UFSAR Chapter 15 System
Transient Analysis Methodology

DPC-NE-3002-A
Revision 3

May 1999

SUBJECT: CATAWBA NUCLEAR STATION, UNIT 2 - TOPICAL REPORT DPC-NE-3002-A,
REVISION TO ADDRESS LOSS OF NORMAL FEEDWATER (TAC MA3702)

Valve S/N N60951-01-0025
6 R 10 Set Pressure = 1220 psig
Sheet 1 of 1

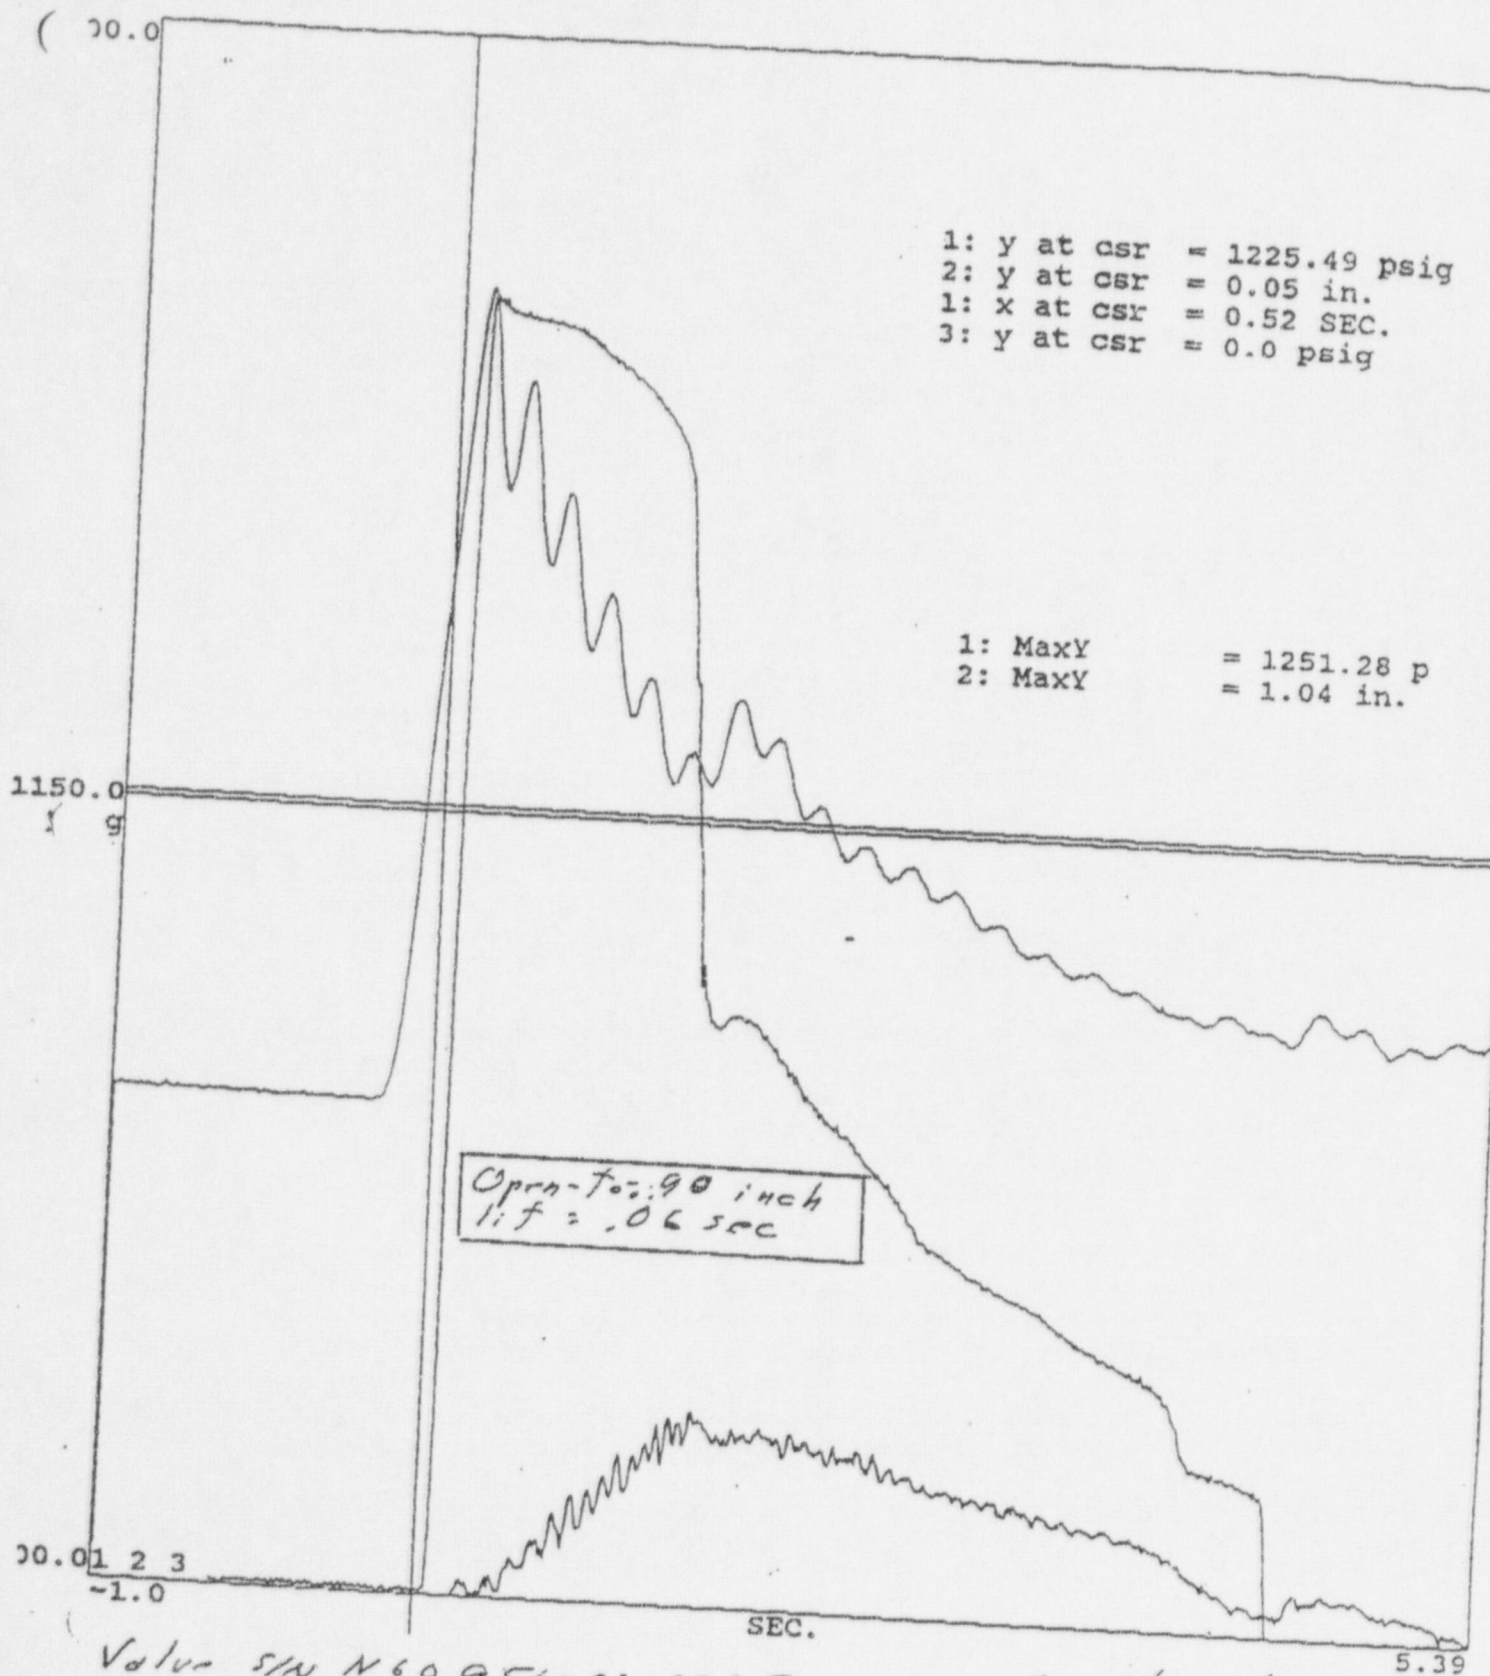
Although the Pressurizer Valve tested by EPRI and the Main Steam Safety Valves tested at Crosby are different styles, they both have a two-ring internal design and are similar in body size. Tests also demonstrate that both style valves, under varying conditions, open with a rapid "pop" at valve setpoint. We would expect similar inlet pressurization rates to have little effect on the opening time of the MSSV's.

Therefore, the tests performed by Crosby, coupled with those performed by EPRI demonstrate valve opening response times under various inlet conditions, are well within the assumed time of 0.500 seconds.
